Addendum #1

Project Name: St Mary Catholic Church – New Parish Hall
Sutton, Nebraska

Project Number: CAC3 – 07039

ADDENDUM

-	ELECTRICAL SITE PLAN	
SCALE: 1/32" = 1'-0"

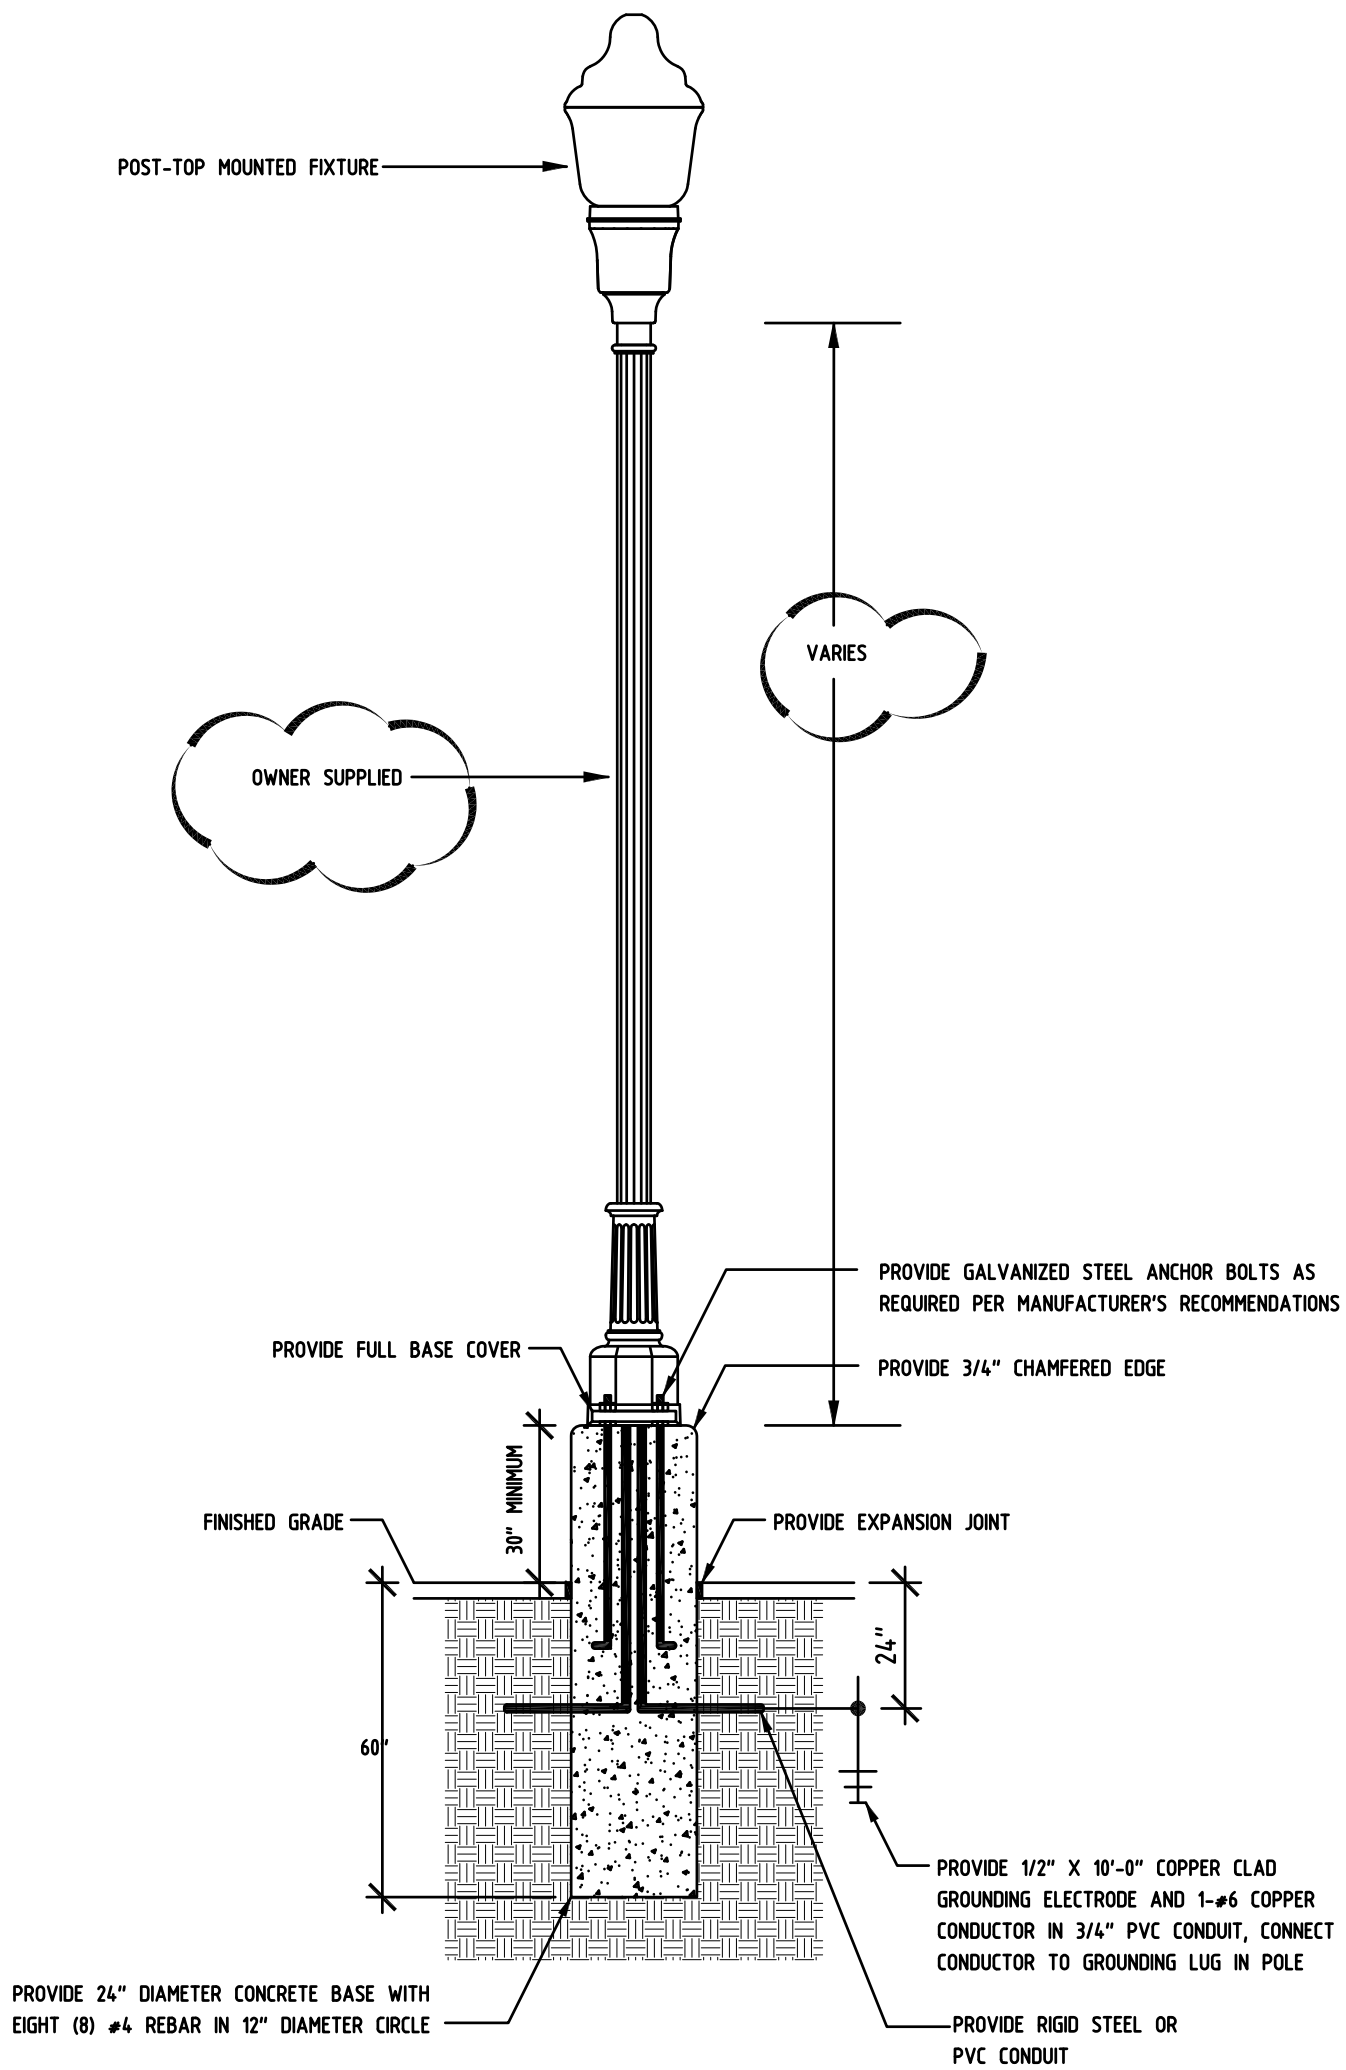
1. Refer to attached Sheet 1 of 2 –
 - a) Contractor to add 1" conduit for future sign.
 - b) The owner will be furnishing two (2) Type #11 pole fixtures. Coordinate exact location with owner.
2. Refer to attached Sheet 2 of 2 –
 - a) The pole base detail has been modified. Coordinate exact requirements with existing owner supplied poles.

KITCHEN 109

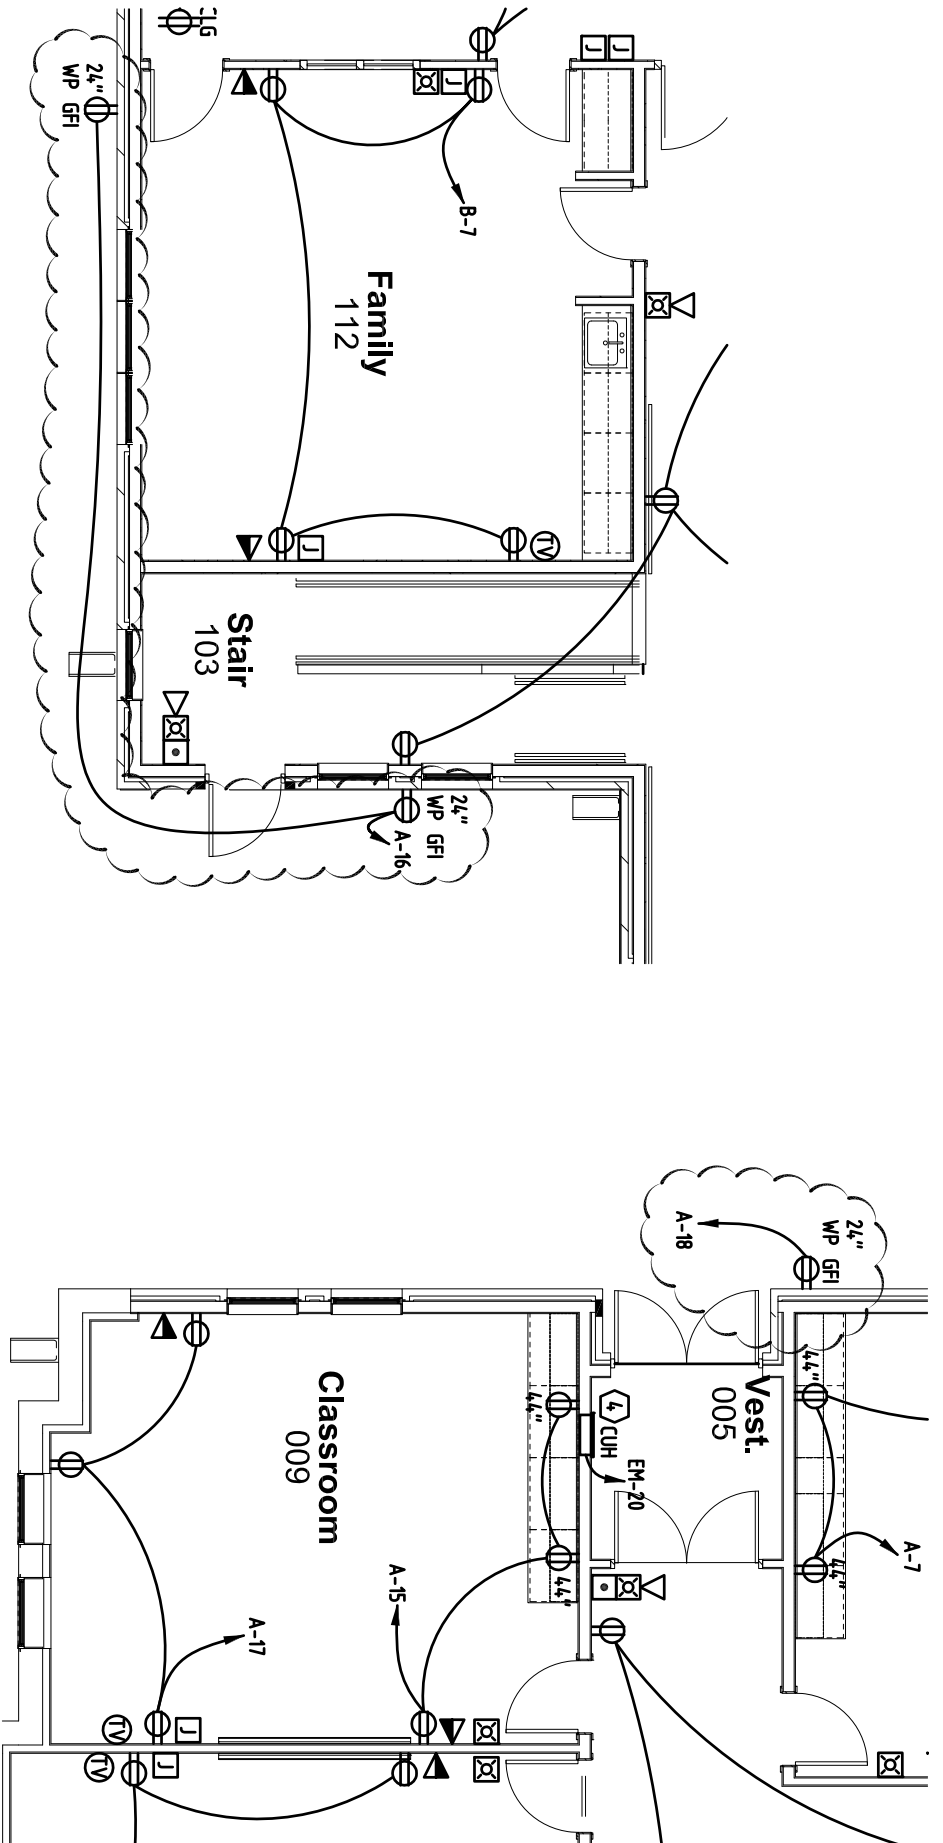
1. Refer to attached Sheet 1 of 2 –
 - a) Contractor shall add clouded circuits to panel 'EM'.
2. Refer to attached Sheet 2 of 2 –
 - b) Contractor shall add new exterior receptacles.
